### **Presentation from the Athabasca Chipewyan First Nation**

### **NexGen Energy Ltd.**

License application to prepare a site for  
and construct its Rook I uranium mine and  
mill project

### **Commission Public Hearing Part 2**

## LACK OF BATEA FOR CONTACT WATER PROCESSING

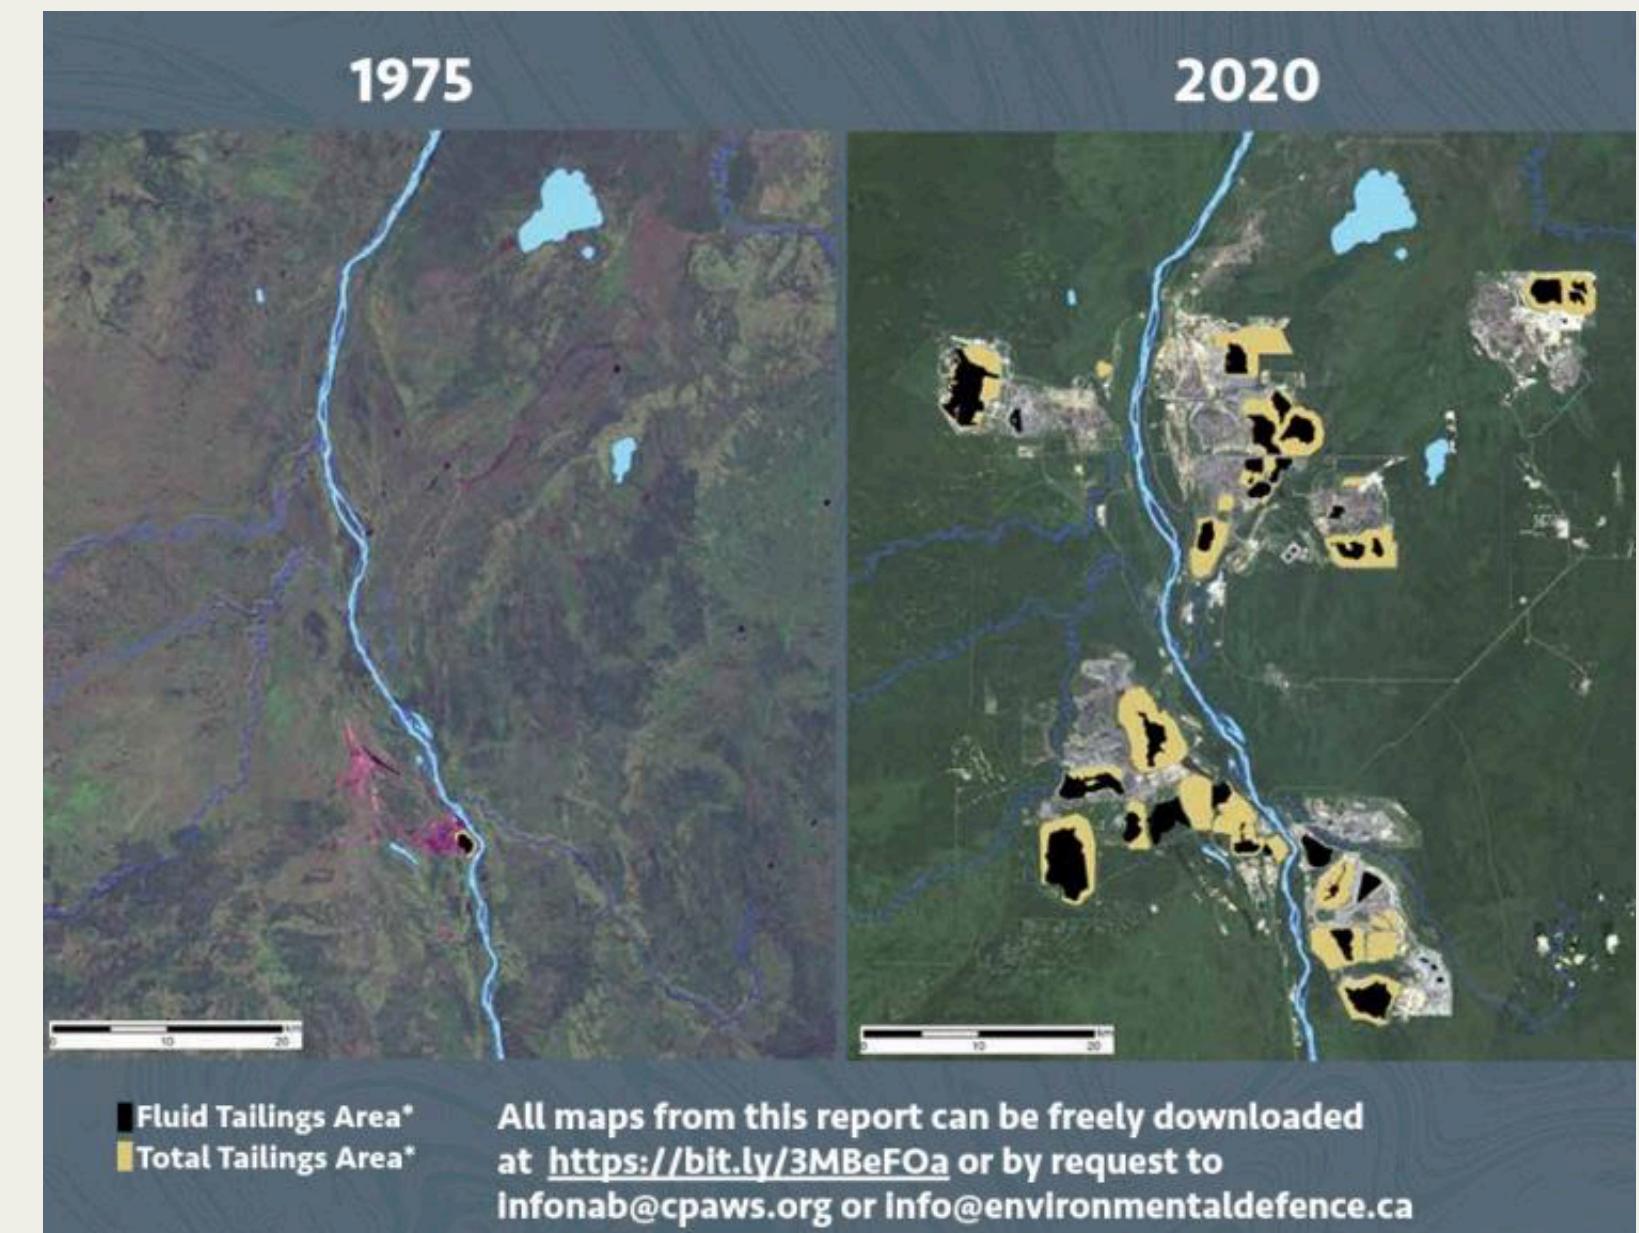
- If licence to construct granted without BATEA, and facility is built, it locks in civil layout, building footprint without public review of BATEA options
- This also makes the ERA/HHRA conclusions conditional on assumed removal efficiencies rather than a defined treatment.
- Risk assessment indicates arsenic (and other constituents) can exceed targets under modestly reduced treatment performance.
- Limited contingency margin and reinforcing that BATEA its public review must be completed before construction.

**Does not yet demonstrate compliance with REGDOC-2.9.2 (BATEA-based design)**
